Access Compliance Report

Public Rights-of-Way

Intersection ID: 10033070	Main Street: NORTH_COMMUNITY_HOUSE_RD	Cross Street: N/A	Location: SW
ADA ID: B2B9FEB37EF2	Ramp Type: Para	Initial Pass/Fail: Fail	Overall Compliance: No
			Severity Score: 26.25

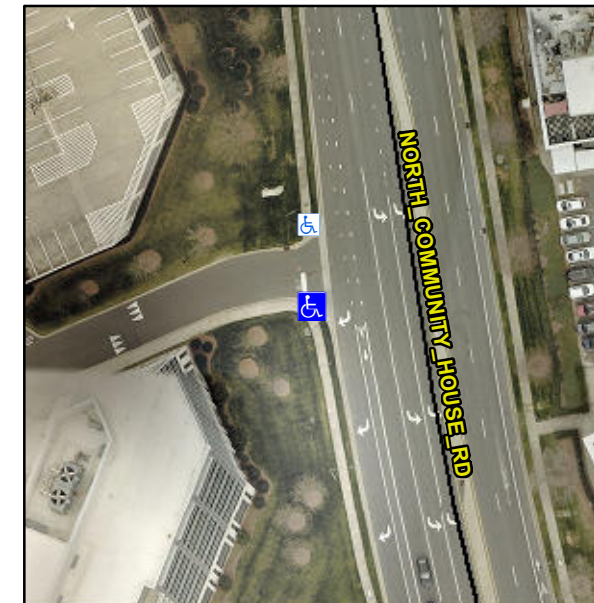
R304.3.2, R304.5.3

Compliance	Description	Data	Compliance	Description	Data
N/A	Ramp Length LT (in)	58.0	N/A	Ramp Length RT (in)	57.5
Yes	Ramp Width LT (in)	59.0	Yes	Ramp Width RT (in)	60.5
No	Ramp Slope LT (%)	10.7	No	Ramp Slope RT (%)	14.6
Yes	Ramp XSlope LT (%)	1.4	No	Ramp XSlope RT (%)	3.9
N/A	Landing Length (in)	N/A	N/A	DWS Provided?	N/A
N/A	Landing Width (in)	N/A	N/A	DWS Contrast?	N/A
N/A	Landing Slope (%)	N/A	N/A	DWS Length (in)	N/A
N/A	Landing X Slope (%)	N/A	N/A	DWS Full Width?	N/A
N/A	Landing Curb? (Y/N)	N/A	N/A	DWS Offset (in)	N/A
N/A	Shared Landing?	N/A			
N/A	Gutter Ponding?	N/A	N/A	Gutter Slope (%)	N/A
N/A	Gutter Lip Ht (in)	N/A	N/A	Gutter X Slope (%)	N/A
N/A	Painted X Walk1?	No	N/A	Painted X Walk2?	N/A
	X Walk 1 Direction	To N		X Walk 2 Direction	N/A
N/A	X Walk 1 Width (in)	N/A	N/A	X Walk 2 Width (in)	N/A
	X Walk 1 Slope (%)	2.4		X Walk 2 Slope (%)	N/A
	X Walk 1 X Slope (%)	5.7		X Walk 2 X Slope (%)	N/A
N/A	Ramp inside XWalk1?	N/A	N/A	Ramp inside XWalk2?	N/A

Remove & Replace Entire Ramp.
